Access Compliance Report

Public Rights-of-Way

Intersection ID: 10036927	Main Street: S_SHARON_AMITY_RD	Cross Street: N/A	Location: SW
ADA ID: FCFE0CBCC2E8	Ramp Type: PerpDiag	Initial Pass/Fail: Fail	Overall Compliance: No
Severity Score: 12.5			
Codes/Mitigation Info/Possible Solution		Field Measurements/Component Compliance

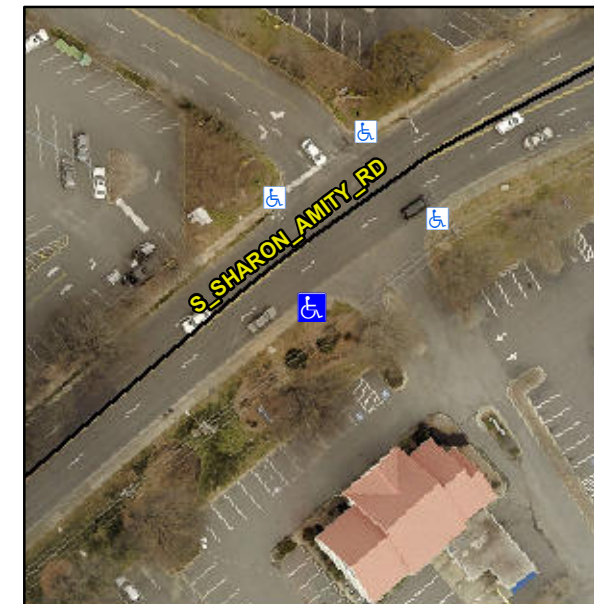
Not Found, R304.2.2

Compliance	Description	Data	Compliance	Description	Data
N/A	Ramp Length (in)	59.5	No	Ramp Slope (%)	9.9
Yes	Ramp Width (in)	48.0	Yes	Ramp XSlope (%)	0.0
N/A	Flare Type LT	N/A	N/A	Flare Type RT	N/A
N/A	Flare Slope LT (%)	N/A	N/A	Flare Slope RT (%)	N/A
N/A	Flare Traversable LT?	N/A	N/A	Flare Traversable RT?	N/A
N/A	Landing Length (in)	N/A	N/A	DWS Provided?	N/A
N/A	Landing Width (in)	N/A	N/A	DWS Contrast?	N/A
N/A	Landing Slope (%)	N/A	N/A	DWS Length (in)	N/A
N/A	Landing X Slope (%)	N/A	N/A	DWS Full Width?	N/A
N/A	Landing Curb? (Y/N)	N/A	N/A	DWS Offset (in)	N/A
N/A	Shared Landing?	N/A			
N/A	Gutter Ponding?	N/A	N/A	Gutter Slope (%)	N/A
N/A	Gutter Lip Ht (in)	1.0	N/A	Gutter X Slope (%)	N/A
N/A	Painted X Walk1?	No	N/A	Painted X Walk2?	No
	X Walk 1 Direction	To NE		X Walk 2 Direction	To NW
N/A	X Walk 1 Width (in)	N/A	N/A	X Walk 2 Width (in)	N/A
	X Walk 1 Slope (%)	3.7		X Walk 2 Slope (%)	5.8
	X Walk 1 X Slope (%)	3.3		X Walk 2 X Slope (%)	3.2

Remove & Replace Curb Ramp With Two New Directional Ramps or Equivalent.
